Review of the Sustained Yield Plan / Habitat Conservation Plan for the properties of The Pacific Lumber Company, Scotia Pacific Holding Company, and Salmon Creek Corporation

Dr. Leslie M. Reid
 USDA Forest Service Pacific Southwest Research Station
 Redwood Sciences Laboratory
 1700 Bayview Drive, Arcata CA 95521

Review of the Sustained Yield Plan / Habitat Conservation Plan for the properties of The Pacific Lumber Company, Scotia Pacific Holding Company, and Salmon Creek Corporation

Figure A4-1A. Cross-sections of Freshwater Creek for 1975 and 1998 at XS-3. Stages identified by USACE (1975) for floods with 100-year and 50-year recurrence intervals are indicated. Cross sections are viewed as looking downstream.

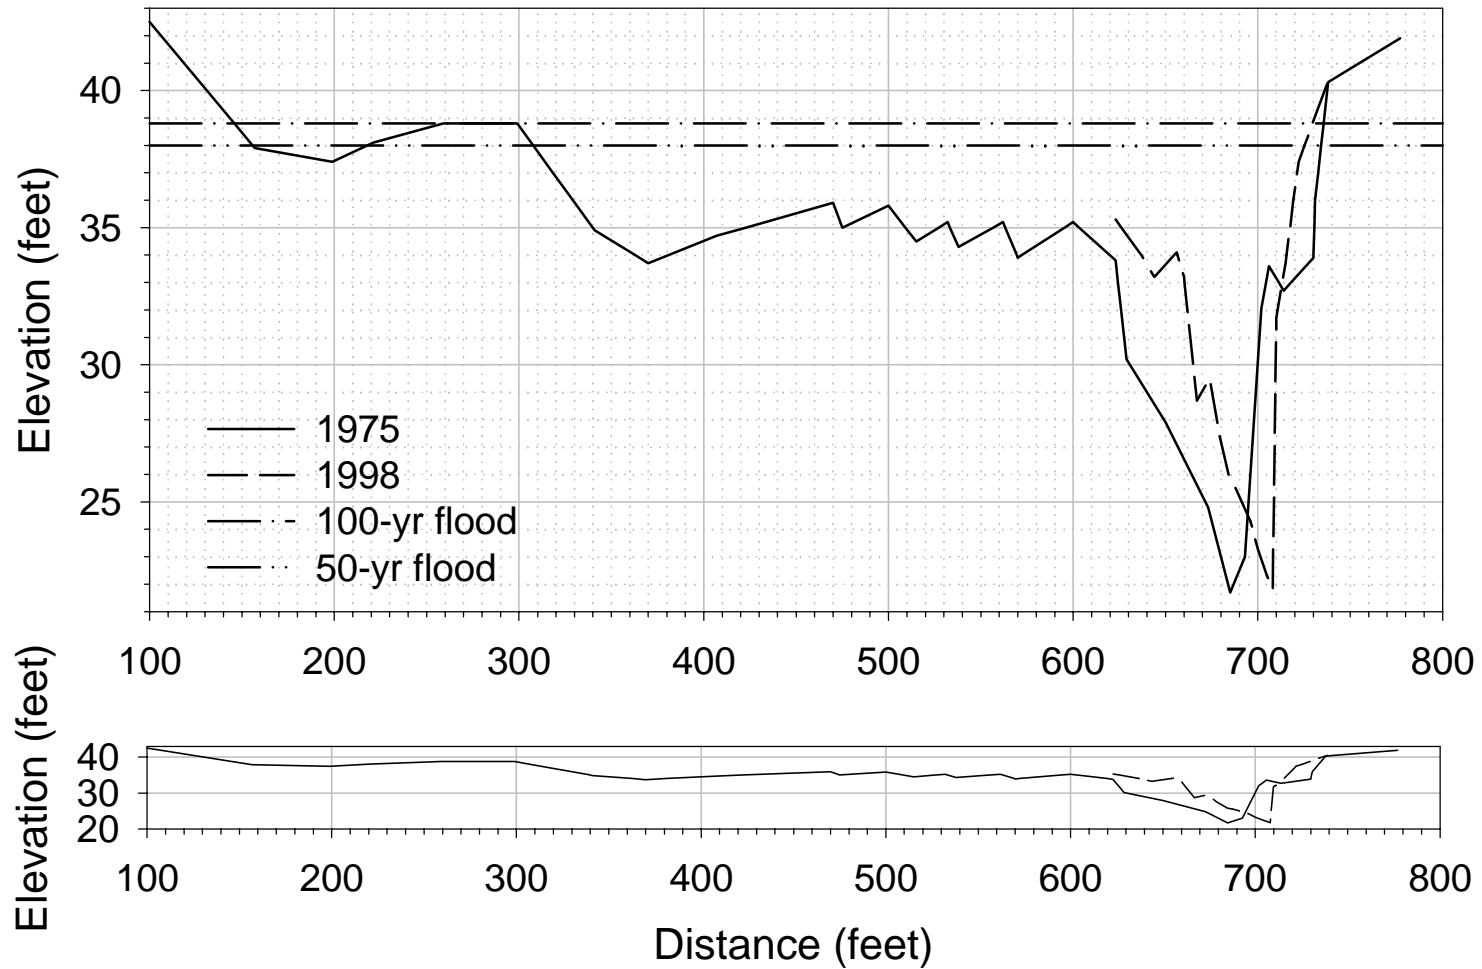
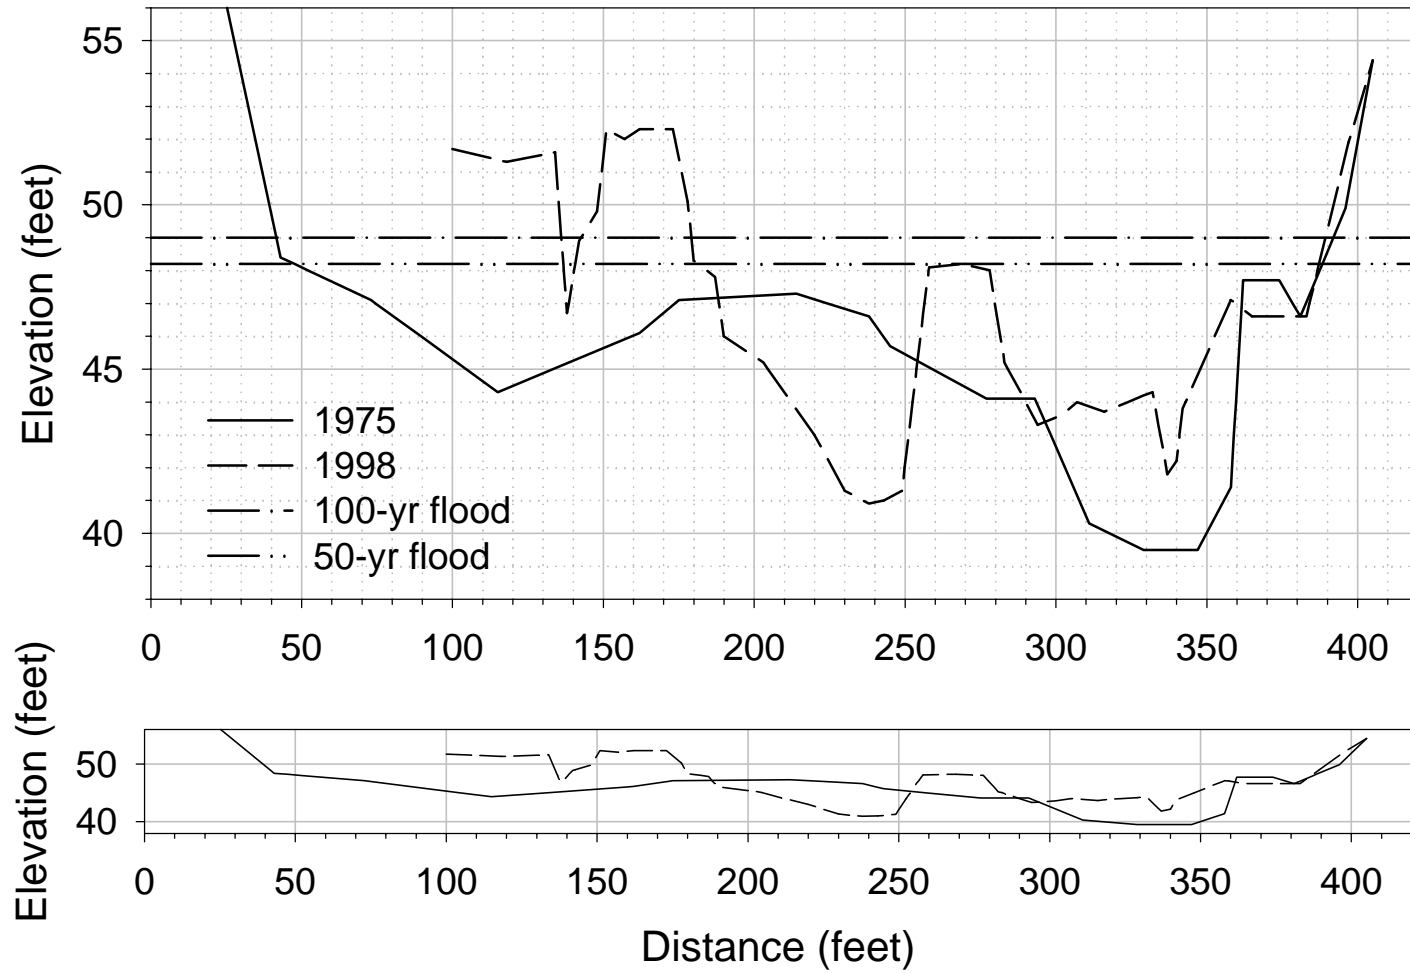
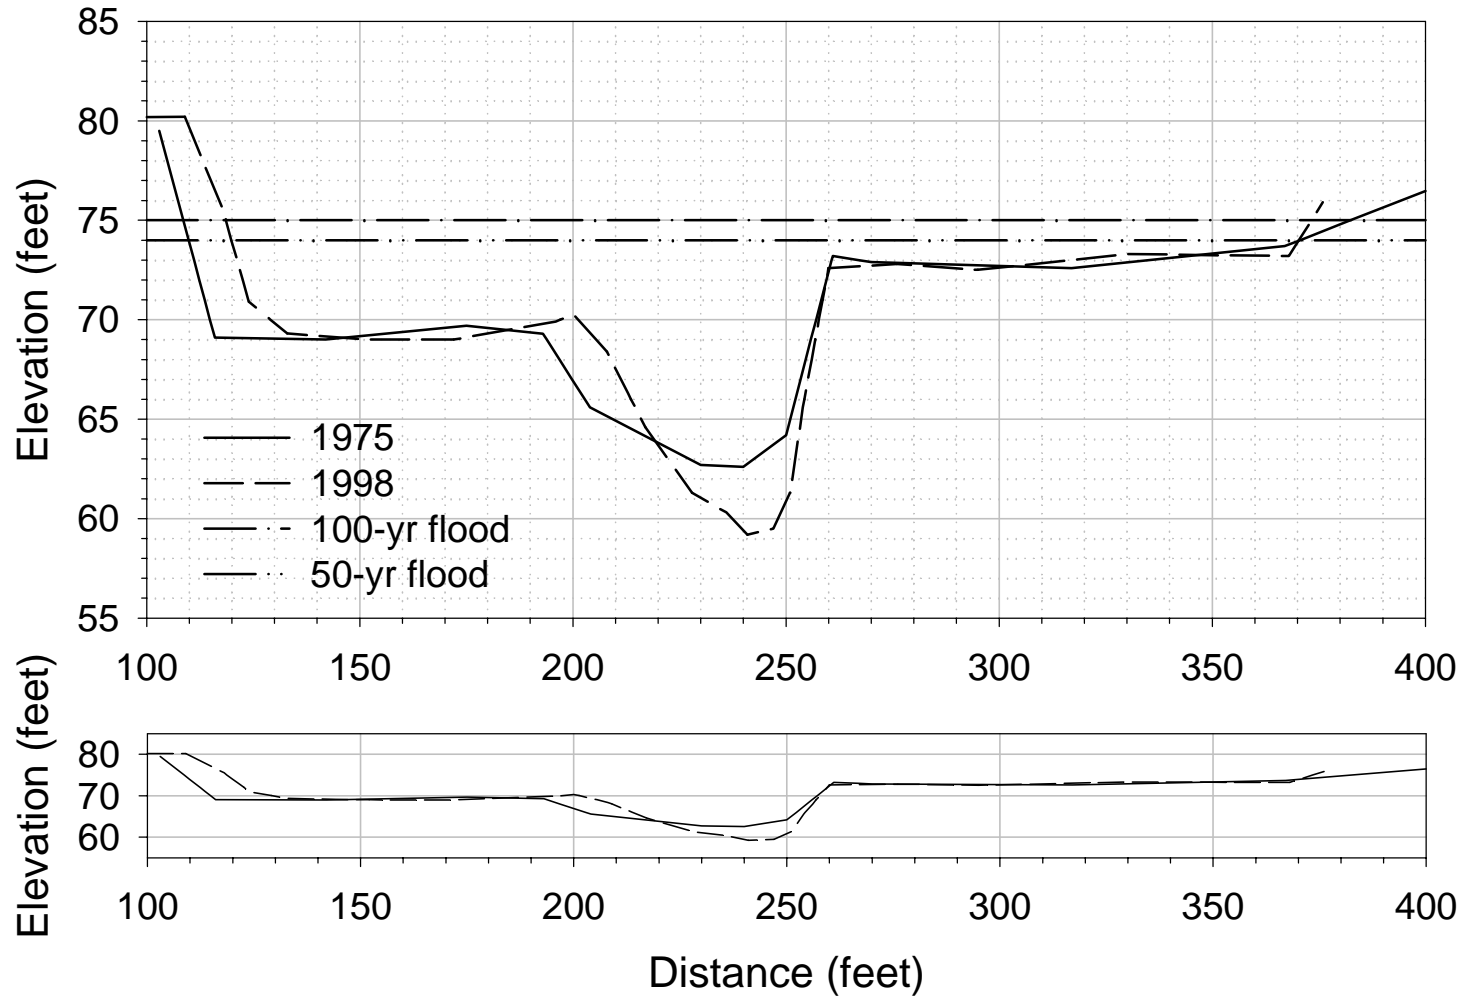
As suggested by Figure A4-1, results show a marked decrease in channel area in sections XS-3 and XS-5, while section XS-7 has changed little. Section XS-3 shows a consistent increase in percent channel constriction with decreasing stage, but this trend is likely to be partially an artifact of the assumption of minimal floodplain sedimentation since the 1975 survey. This assumption is moot for stages at or below 35 feet, and at a 35-foot stage, the 34% reduction in channel area is similar to the magnitude of change observed at XS-5. Aggradation of an additional average of 20 cm of sediment over the 50-year floodplain would have been sufficient to decrease the cross-sectional area of the 50-year flood by 30%.
